ADDENDUM #1

PROJECT: Secure Entry Office Addition and Building/Site updates
at Manor Elementary School
for Monroe Public Schools
#20161

86 MAIL ELEVATION
A8.20 SCALE: 1/2" = 1'-0"

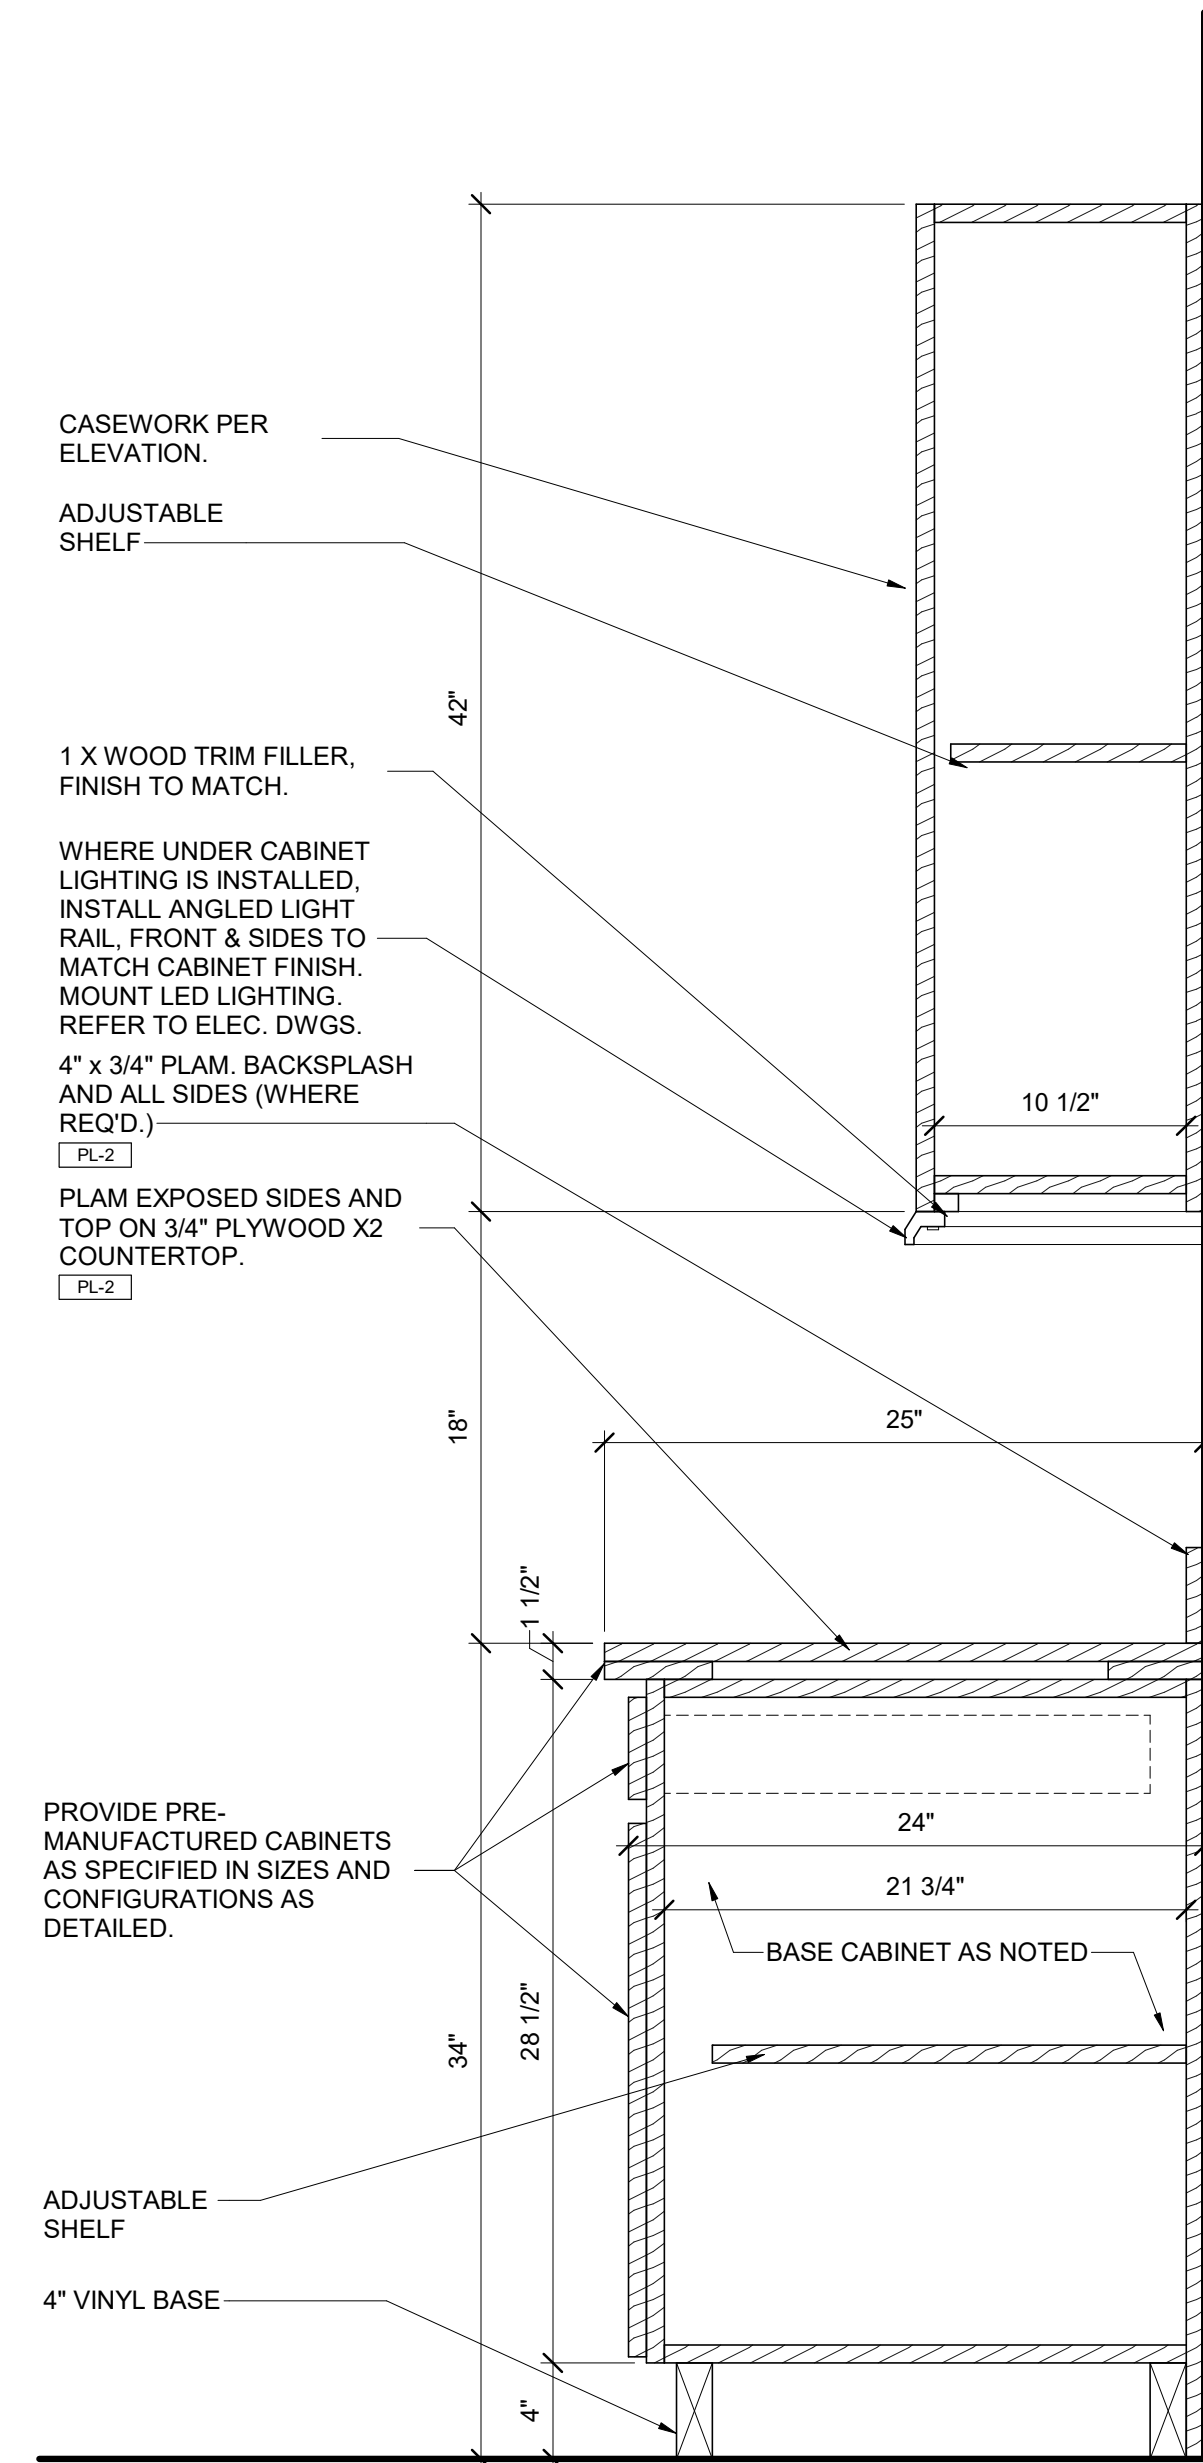
- 4. Added elevation detail 86/A8.20 – “MAIL ELEVATION”
- I. A9.00 – DOOR SCHEDULE / DOOR & FRAME TYPES (RE-ISSUED HEREIN)
 - 1. “DOOR SCHEDULE” has been updated.

85 MAIL ENLARGED PLAN
A7.01 SCALE: 1/2" = 1'-0"

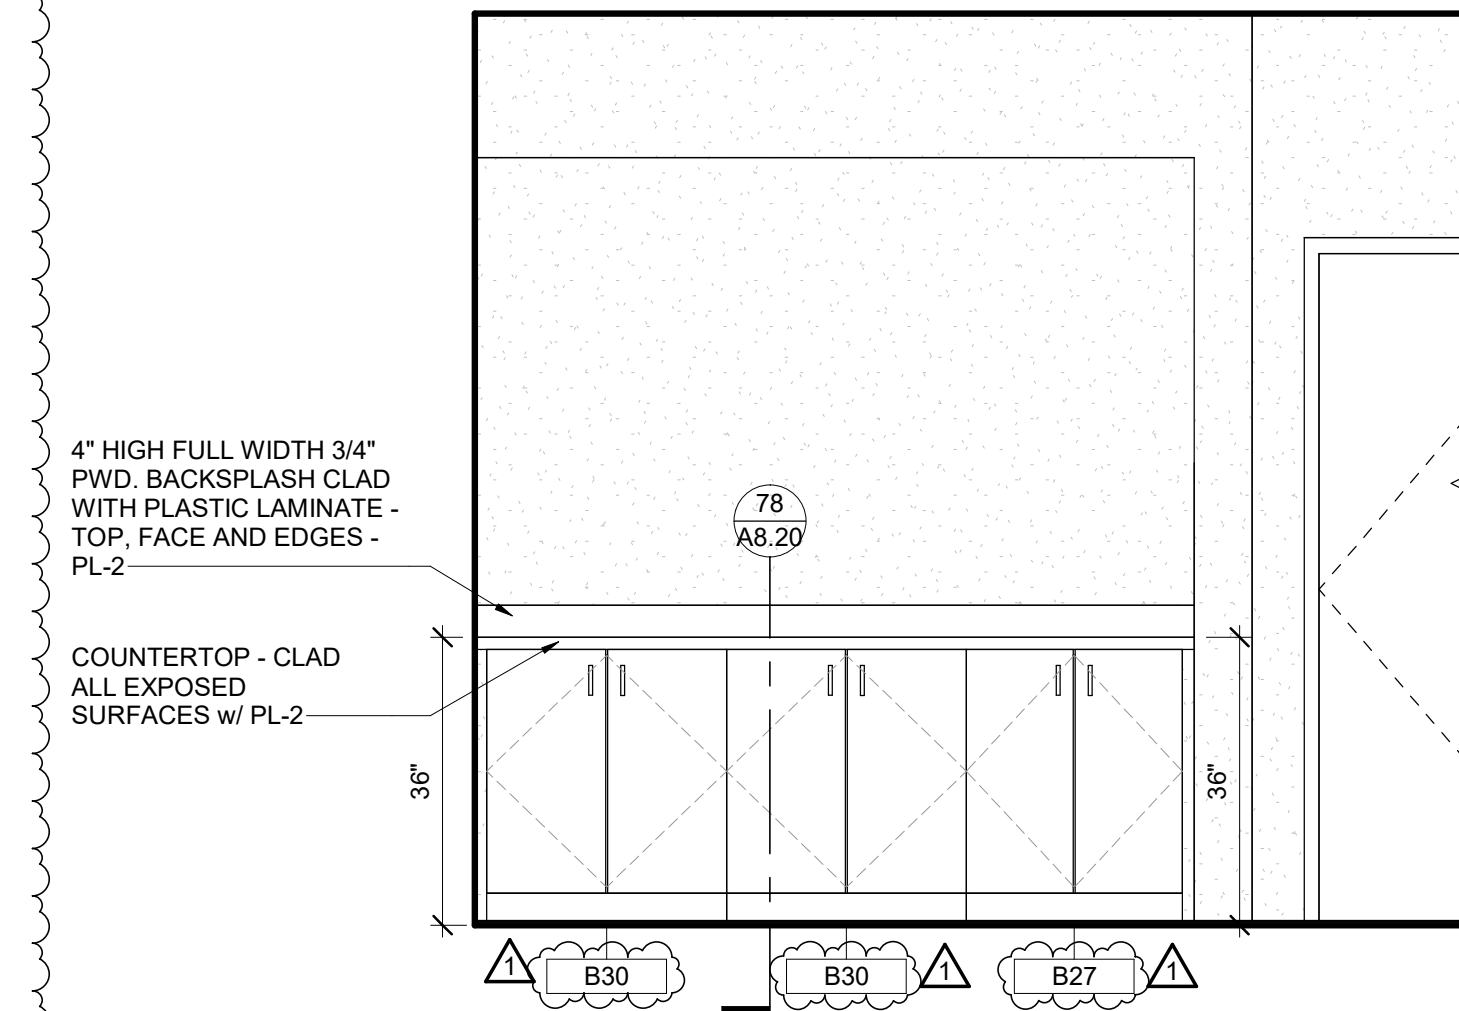
- 2. Elevation 76/A8.20 – “CONFERENCE ROOM ELEVATION” Millwork Tags were added for coordination.
 - 3. Added plan detail #85/A7.01 – “MAIL ENLARGED PLAN”

DOOR ELEVATIONS

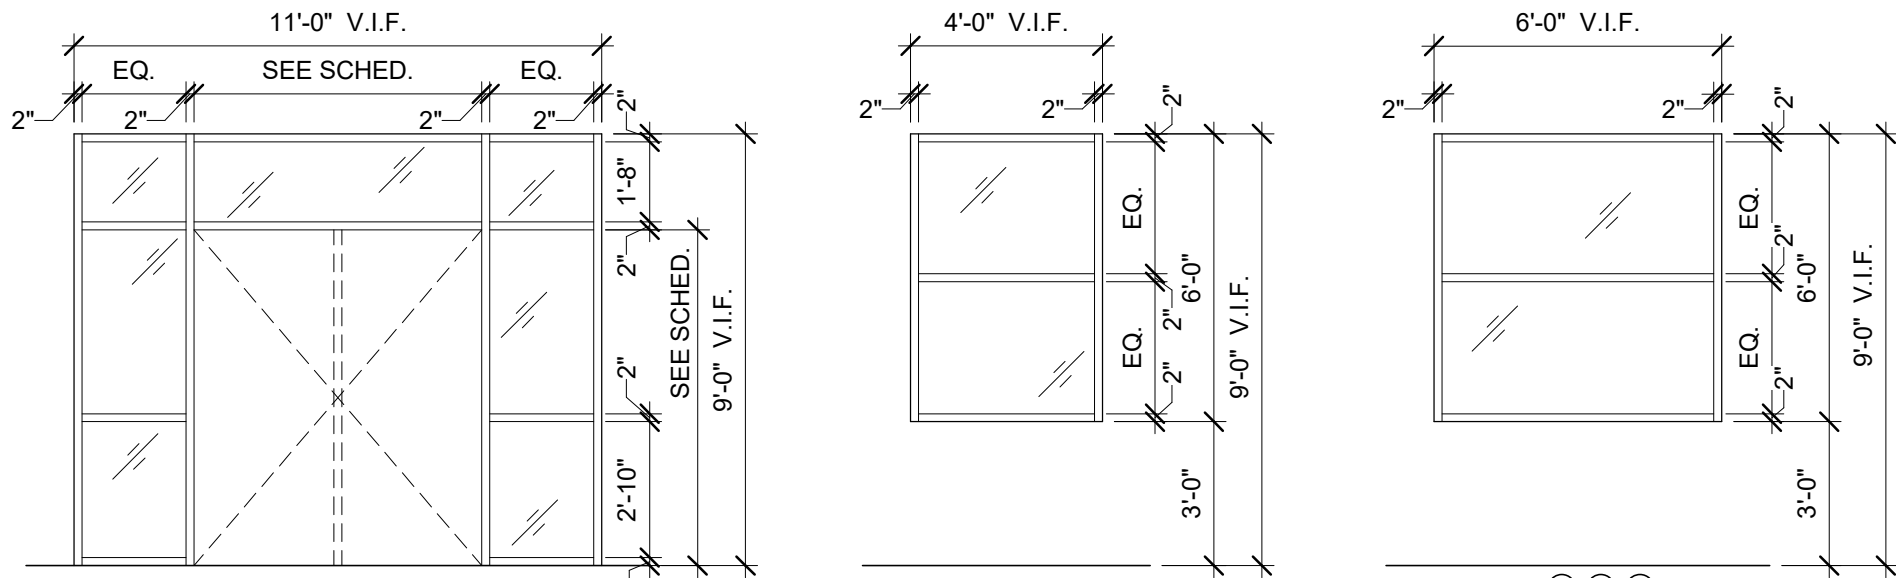
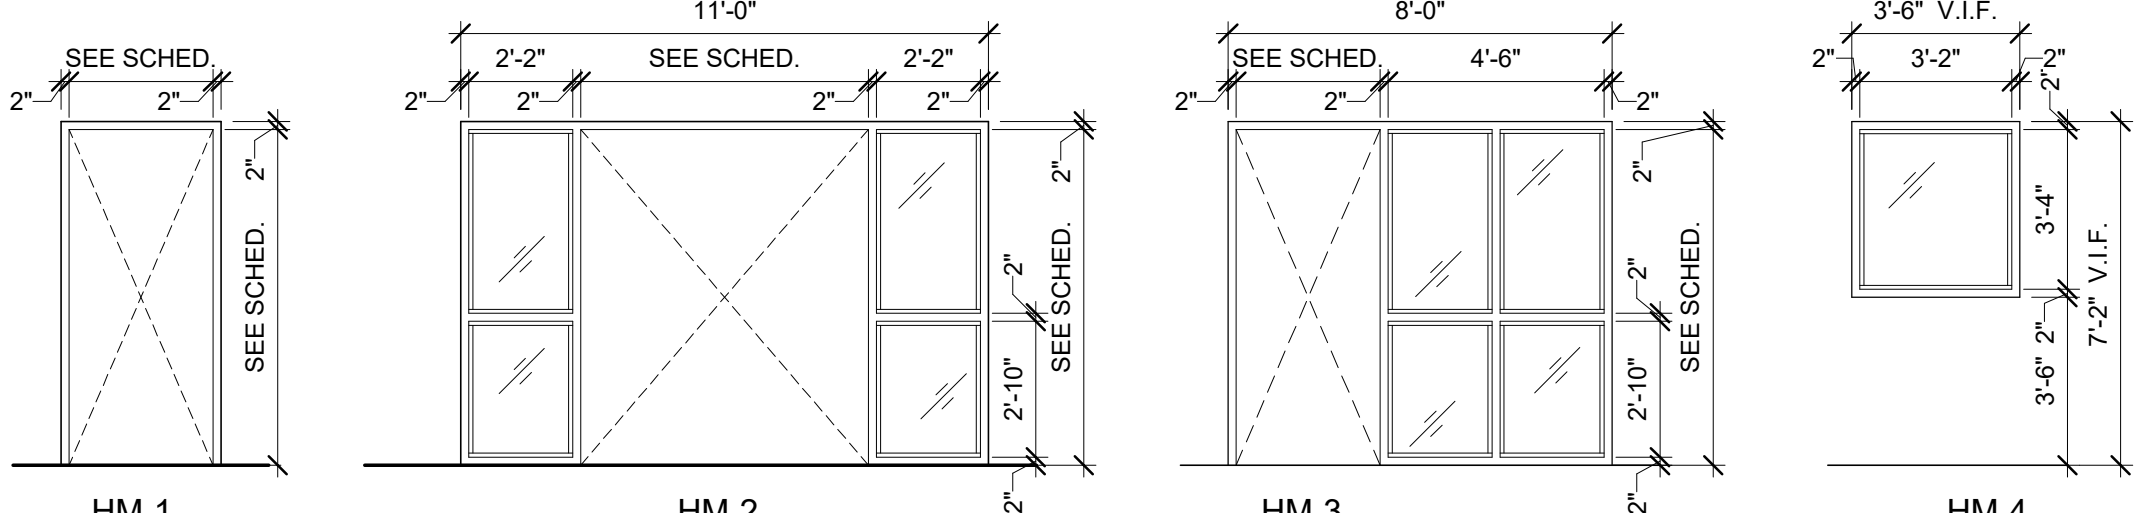
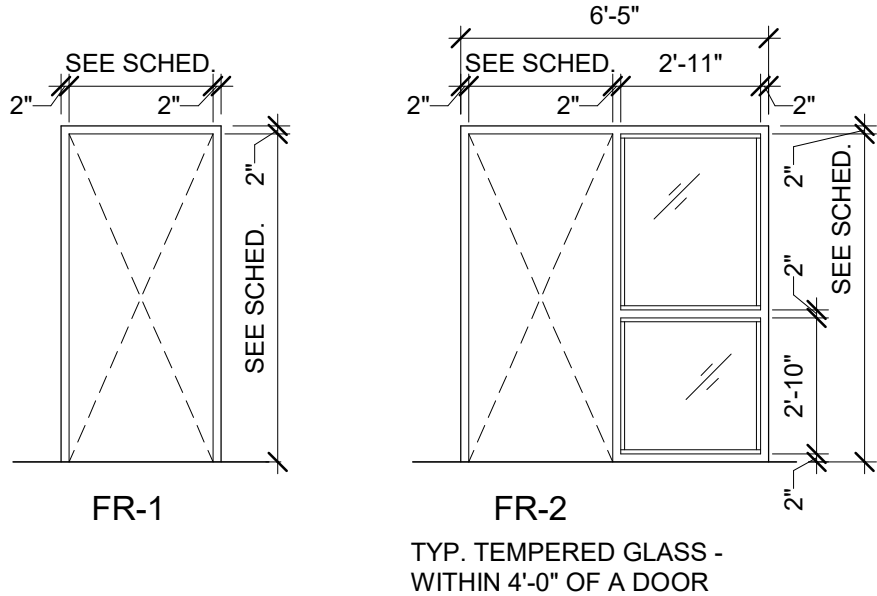
- 2. “DOOR FRAMES” has updated elevation.
